Palo Verde Nuclear
Generating Station

**Subject: Palo Verde Nuclear Generating Station (PVNGS) Units 1, 2, and 3
Docket Numbers STN 50-528, 50-529, and 50-530
Request for Amendment to Technical Specification Table 3.3.5-1,
Engineered Safety Features Actuation System Instrumentation, and
Figure 3.5.5-1, Minimum Required Refueling Water Tank (RWT)
Volume and Supporting Changes**

Enclosure
**Evaluation of the Proposed Change to TS Table 3.3.5-1, Figure 3.5.5-1, and
Supporting Changes**

Subject: Request for Amendment to Technical Specification Table 3.3.5-1, Engineered Safety Features Actuation System Instrumentation, and Figure 3.5.5-1, Minimum Required Refueling Water Tank Volume and Supporting Changes

FIGURE 3.5.5-1
Minimum Required RWT Volume

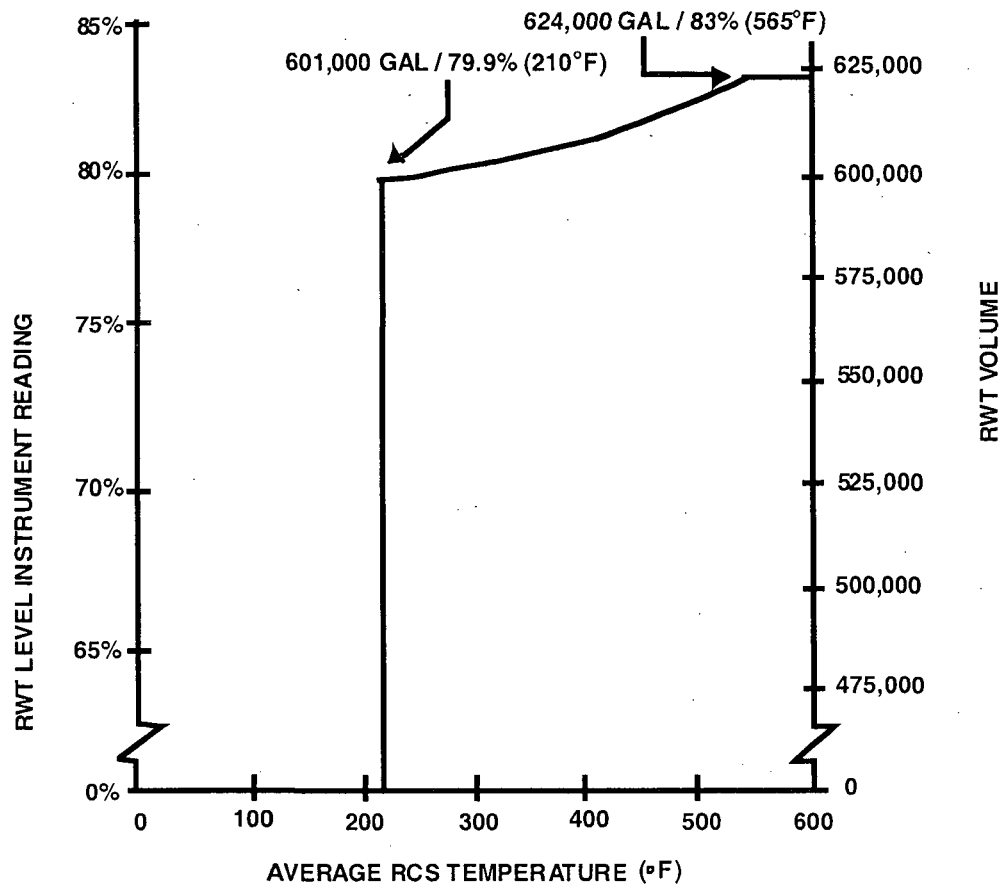
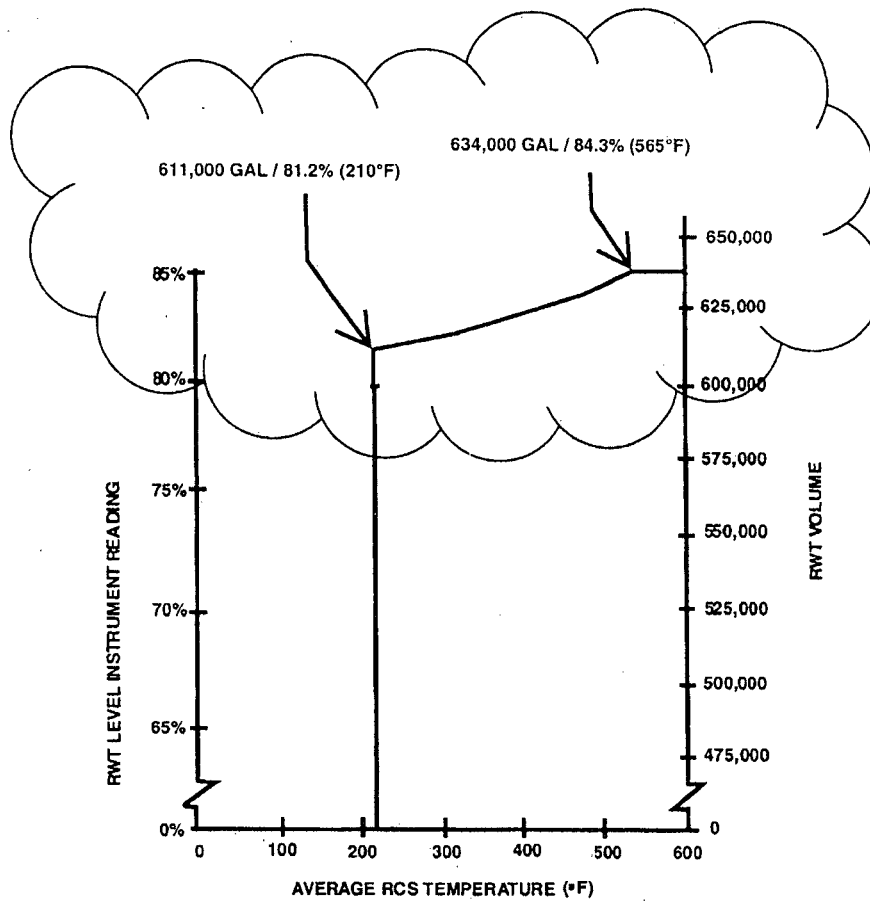
- Increases the minimum required RWT volume in Figure 3.5.5-1 of TS 3.5.5, from 601,000 gallons at 210°F to 611,000 gallons at 210°F to accommodate the proposed (higher) RAS setpoint Allowable Values. Additionally, the minimum RWT volume at 565°F will be increased from 624,000 gallons to 634,000 gallons. The minimum RWT volume between 210°F and 565°F shown in TS Figure 3.5.5-1 is also increased proportionally per APS Calculation 13-JC-CH-0209 (Reference 6.1). This change will ensure sufficient borated water is delivered from the RWT during the ECCS injection mode before switchover occurs at the proposed (higher) RAS setpoint.

Currently, operators are directed by procedure to isolate the RWT following a RAS; however, this action is not time dependent. Based on the potential for air entrainment during a limited range of small break LOCAs, RWT isolation will now be completed within a specific period following a RAS. The proposed TS change to raise the RAS Allowable Values (TS Table 3.3.5-1) is to accommodate the time necessary for the operators to perform this action before the RWT vortex breaker could be uncovered. To ensure a sufficient volume of borated water is transferred from the RWT before a RAS, the minimum RWT levels (TS Figure 3.5.5-1) must also be raised.
